Product Change Notification

Date Issued :	February 06, 2025	PCN Number :	516529
Reason for Change :	Change to Product		
Description of Change :	This notification is to inform you that the previously issued PCN516309 is to be cancelled with this PCN. Molex decided to return to the state before the change after discussing with the customer. Please refer to the information below for details.		
Reason for Short Notice :	Update Previously Issued Change Notice		
Assessment of Change :	No change to parts - Form/Fit/Function		
Planned Implementation Date :	March 01, 2025		
Customer Sample Availability Date:	February 10, 2025		
Last date to request Samples by Customer :	February 25, 2025		
Please note if Samples are not requested as per Customer Samples Request date, it may take additional 4-6 weeks to arrange Samples.			
Traceability Code Markings / Date :	No special marking on the product or packaging

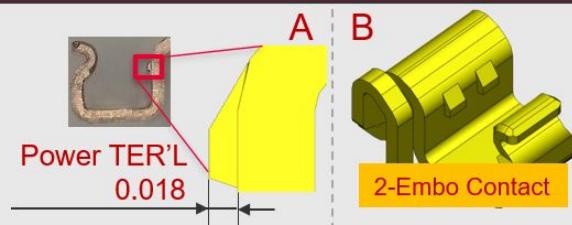
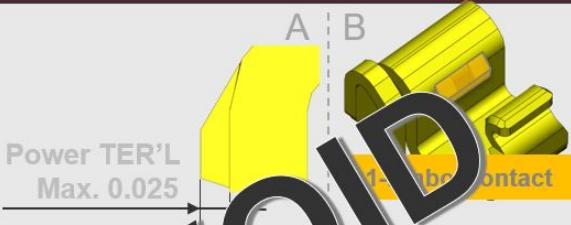
- This change is to void PCN516309 in order to keep the status quo prior to the change without applying the change in PCN516309.
- PCN516309 issued on Nov 28, 2024 and communicated with customers for the following :

molex Product Change Notification			
Date Issued :	December 06, 2024	PCN Number :	516309
Reason for Change :	Change to Product		
Description of Change :	This notification is to inform you that molex will be making a change to power contact terminal of the parts listed in this notice. we will change contact shape and height and please see below for more details.

- Although PCN516309 has been completed, there is no impact on the customers because the changed products have no history of being shipped to the customers.
- Part Number Impact
 - 2202500061 and 2202500069

- In the table below, we would like to void the change(after) of PCN516309 and keep the status before the change by PCN516529.

ITEM	BEFORE – PCN516529	AFTER - PCN516309
Change Points (Unit : mm)	 <p>Power TER'L 0.018</p> <p>A B</p> <p>2-Embo Contact</p>	 <p>Power TER'L Max. 0.025</p> <p>A B</p> <p>1-Embo Contact</p>
Improvement Point	<p>Withdrawal force : AVG 6.0N</p> 	<p>Withdrawal force : AVG 7.0N</p>
